**ADDENDUM  
NO. 3**

**October 11, 2024**

**Whiteland High School Ph 2: Café Kitchen Band Choir Auditorium**  
**300 E. Main Street**  
**Whiteland, IN 46184**

**SECOND FLOOR TECHNOLOGY PLAN - UNIT P.1**

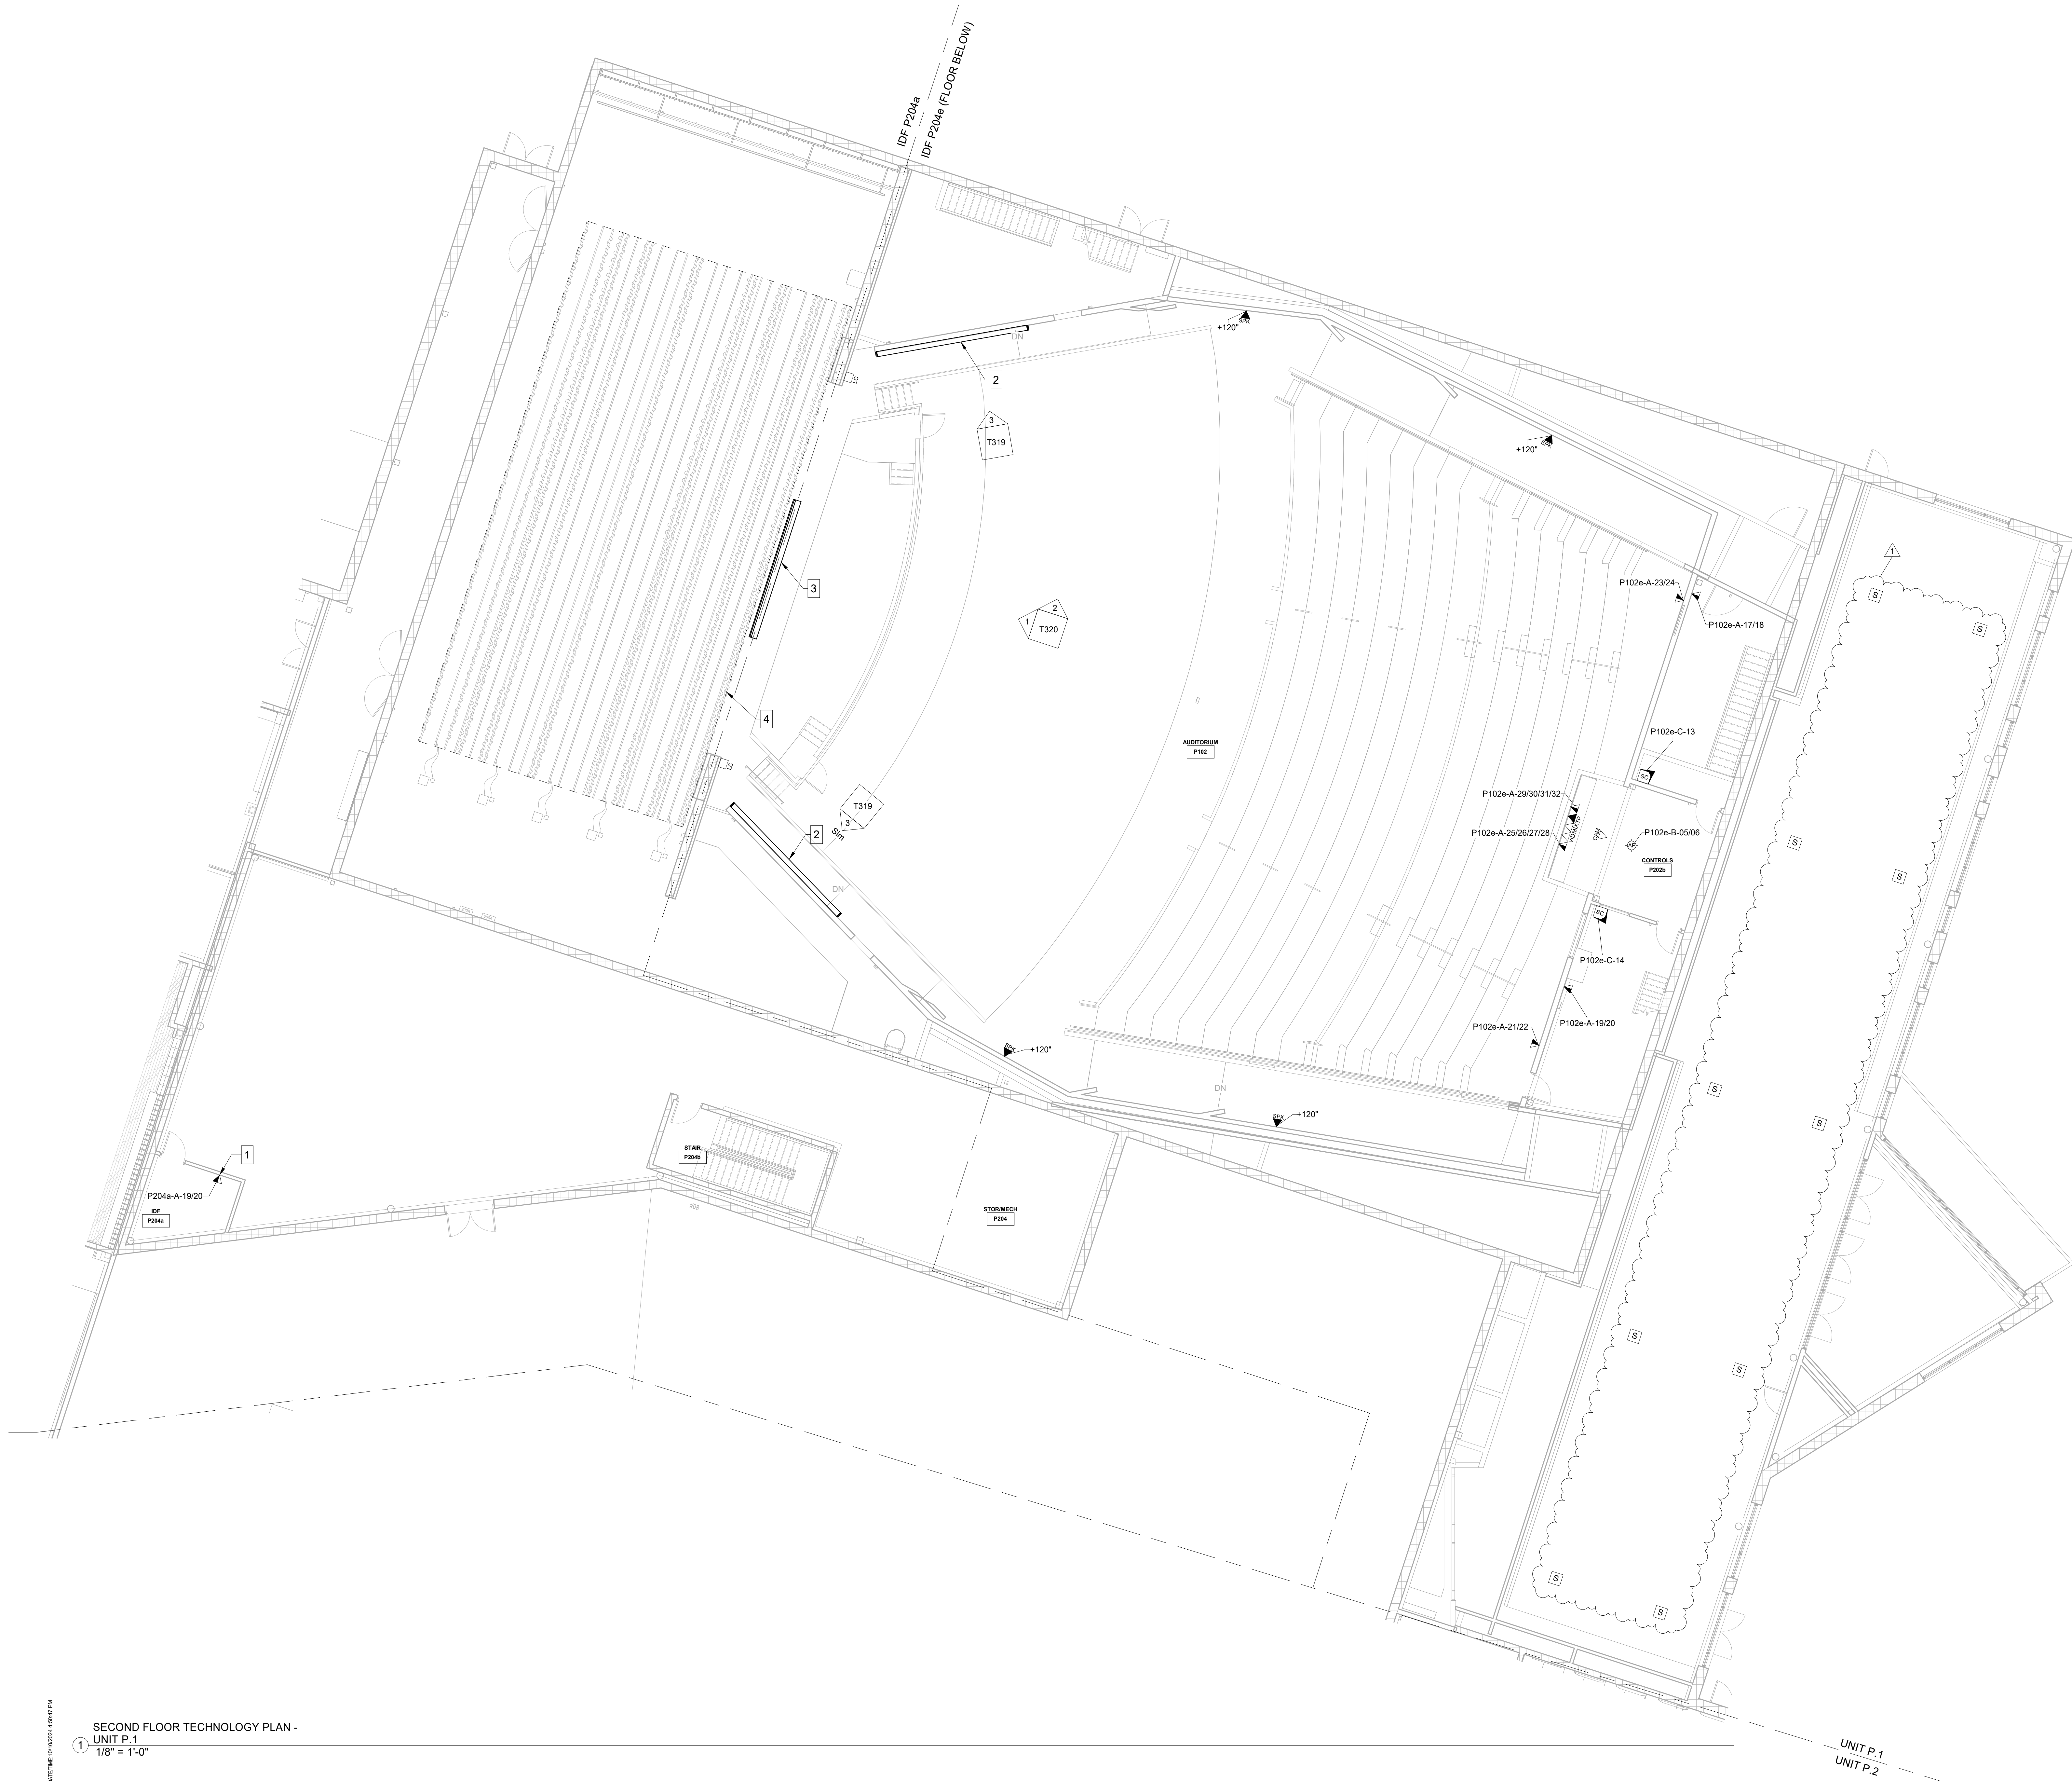
- a. Updated ceiling loudspeaker layout according to reflected ceiling plan

3 CHOIR 2 REHERSAL ROOM AV DIAGRAM  
 N.T.S.

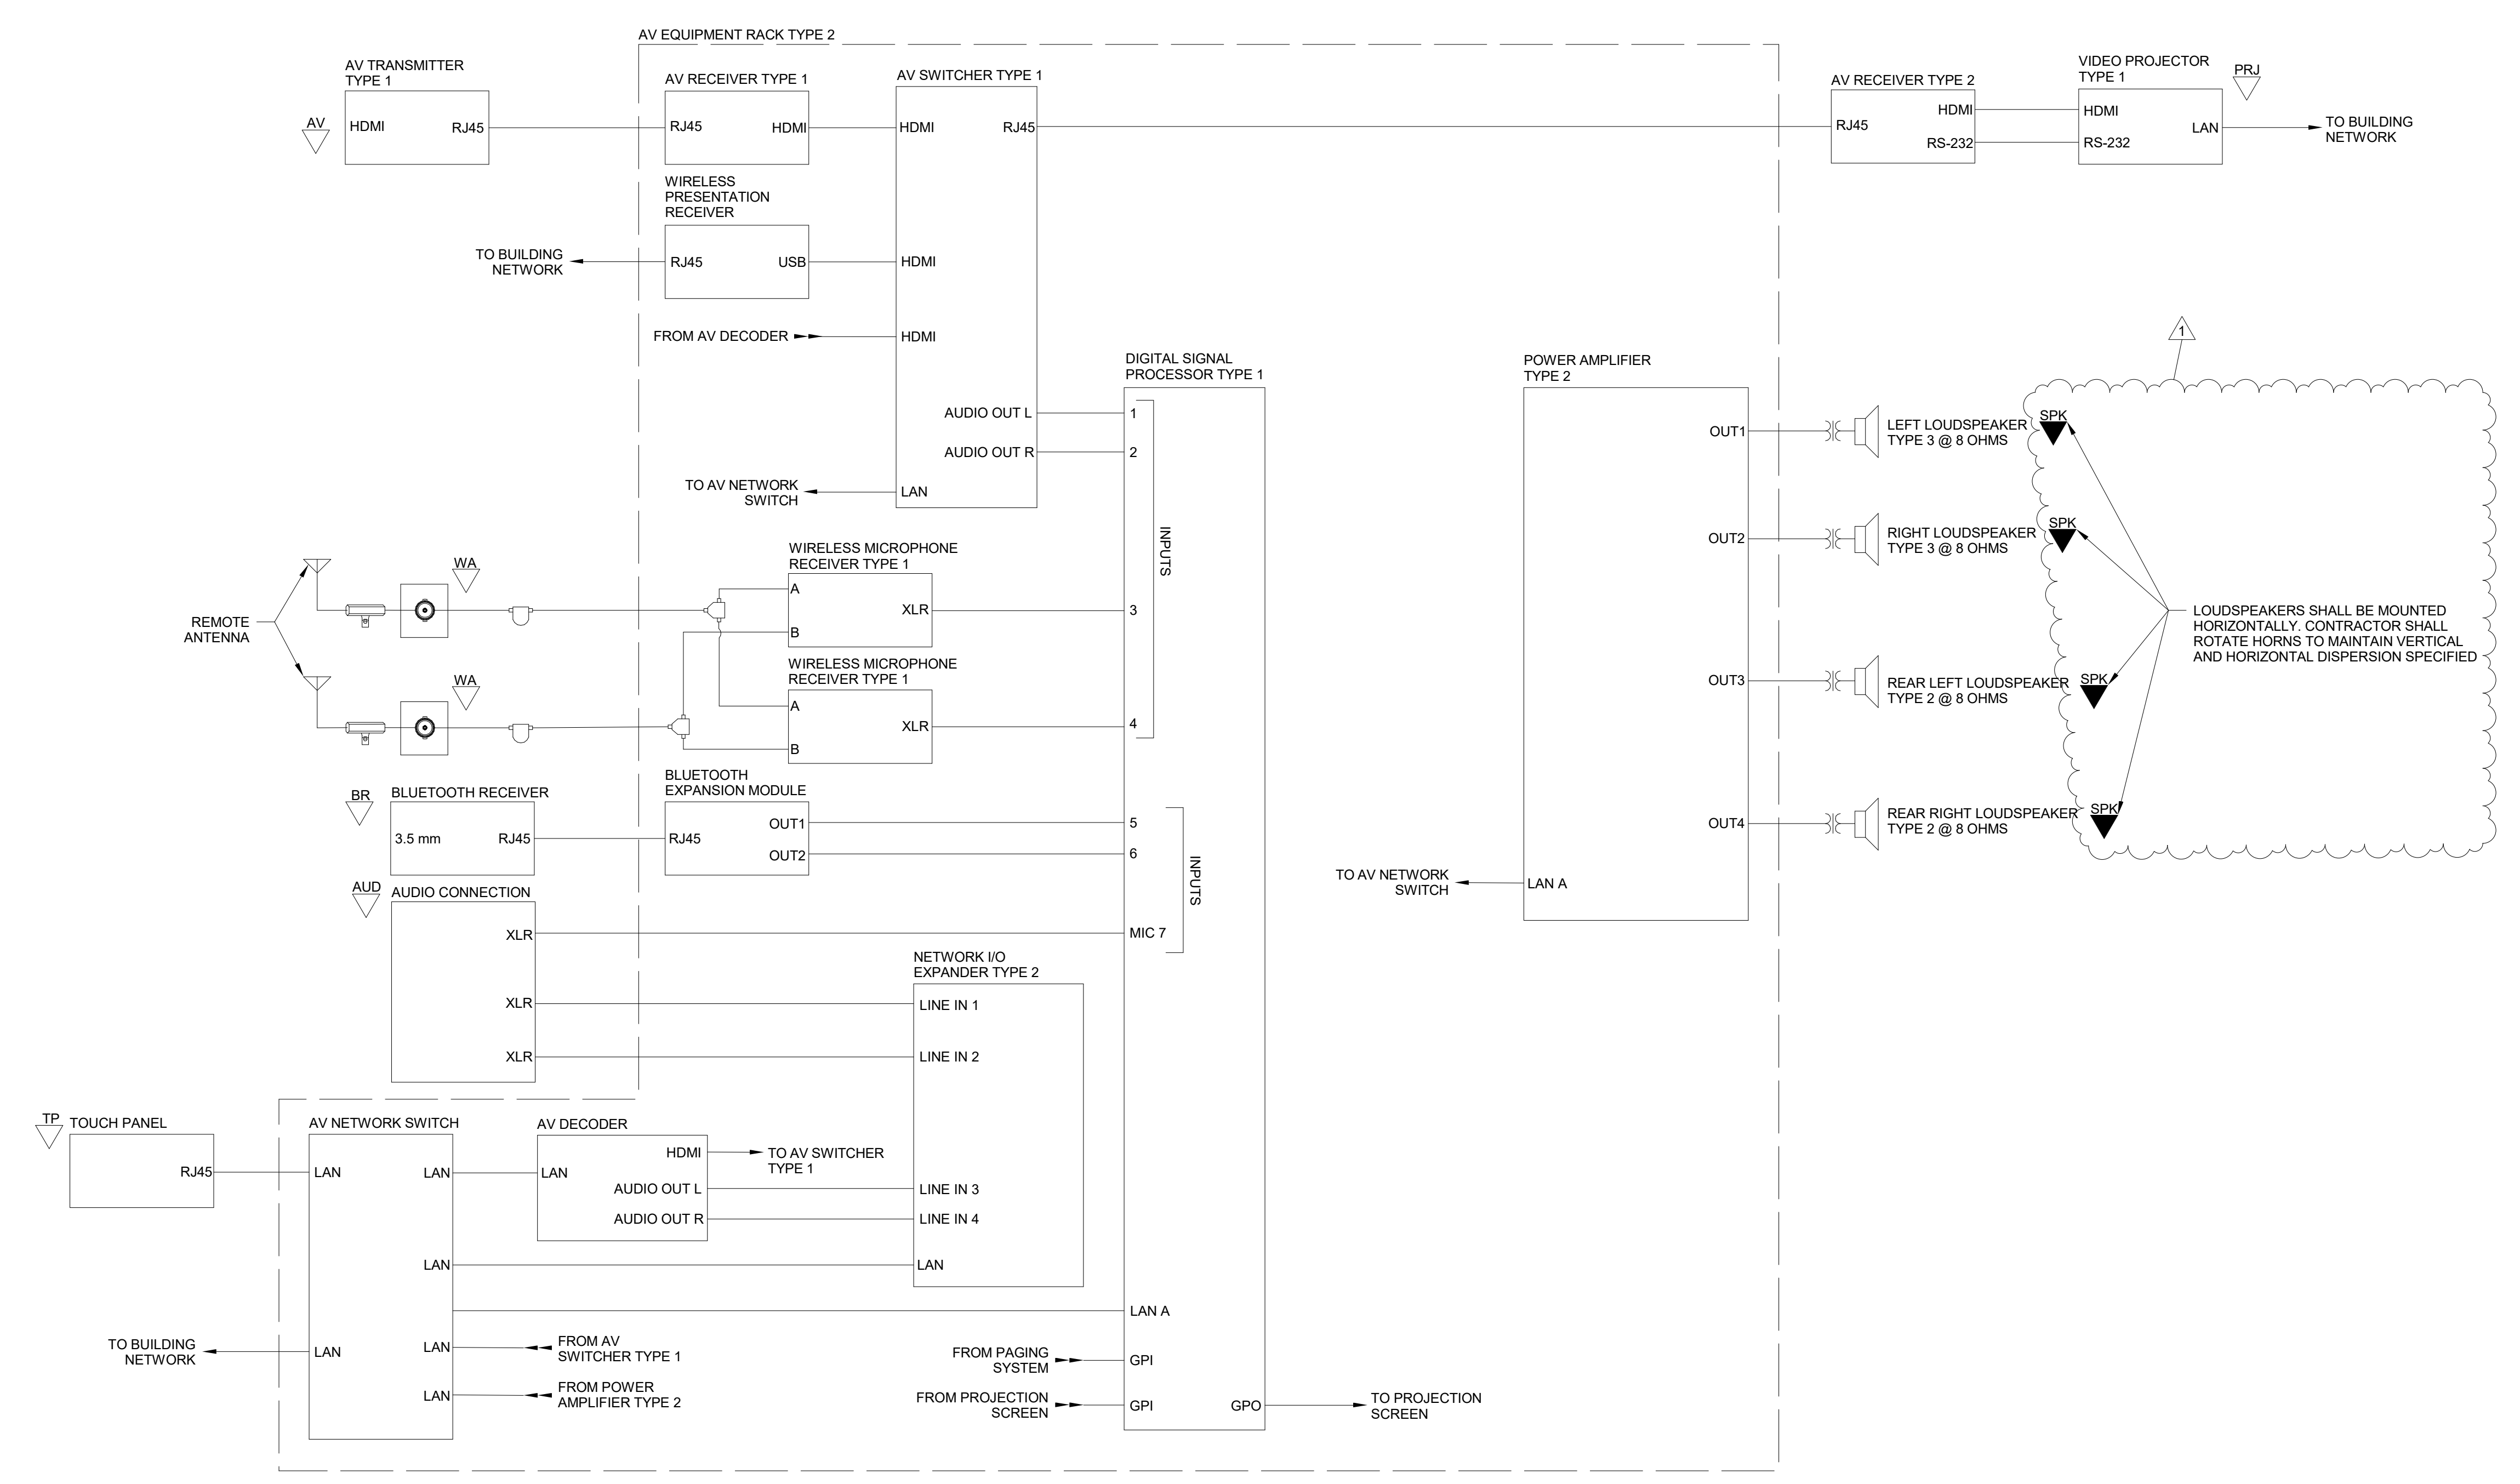
- a. Added additional loudspeaker installation instructions to Choir 2 Rehearsal Room AV Diagram

① DANCE / THEATER REHEARSAL ROOM AV DIAGRAM  
N.T.S.

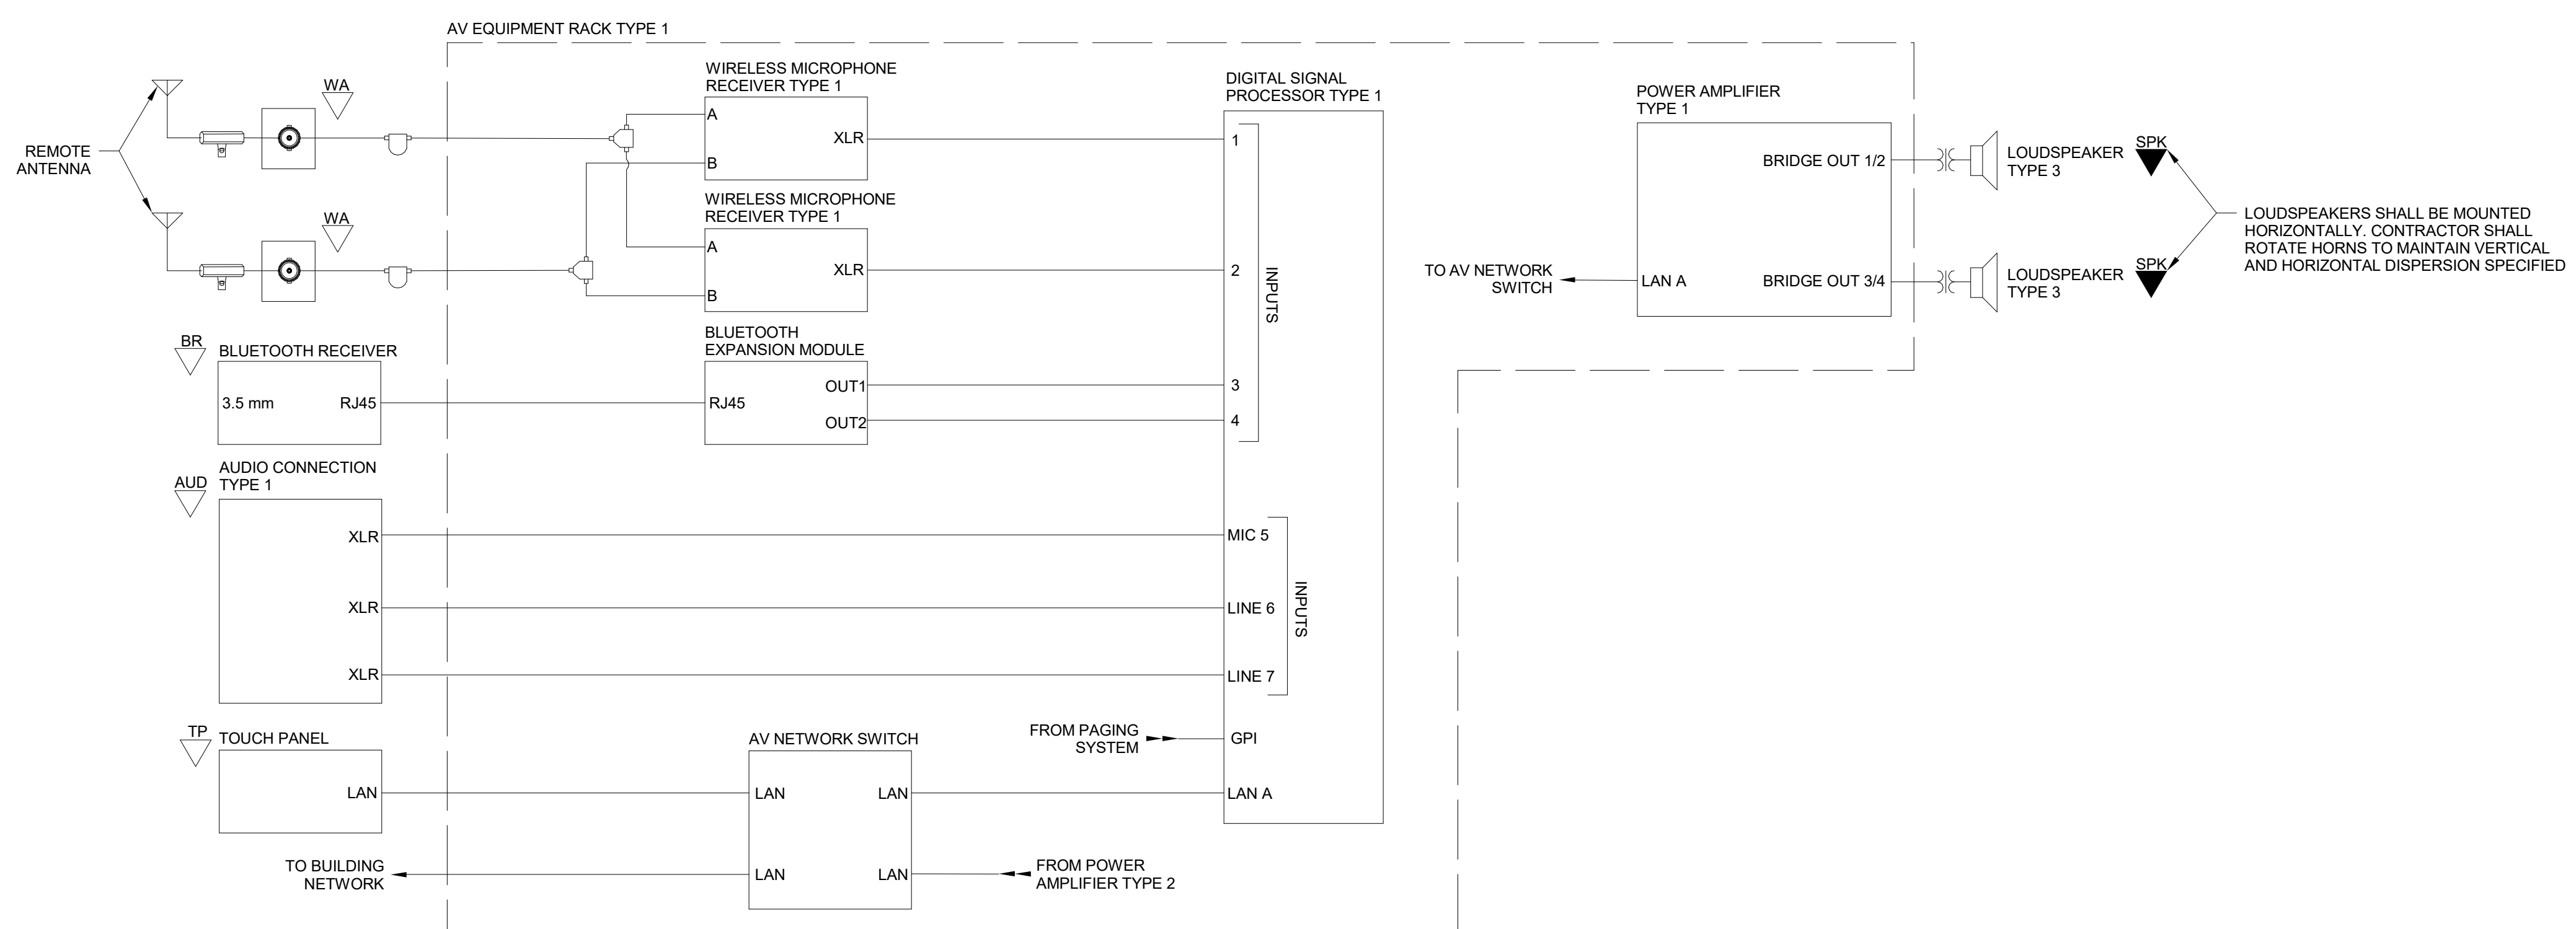
- a. Added output bridging designation to power amplifier type 1 in the Dance/Theater Rehearsal Room AV Diagram
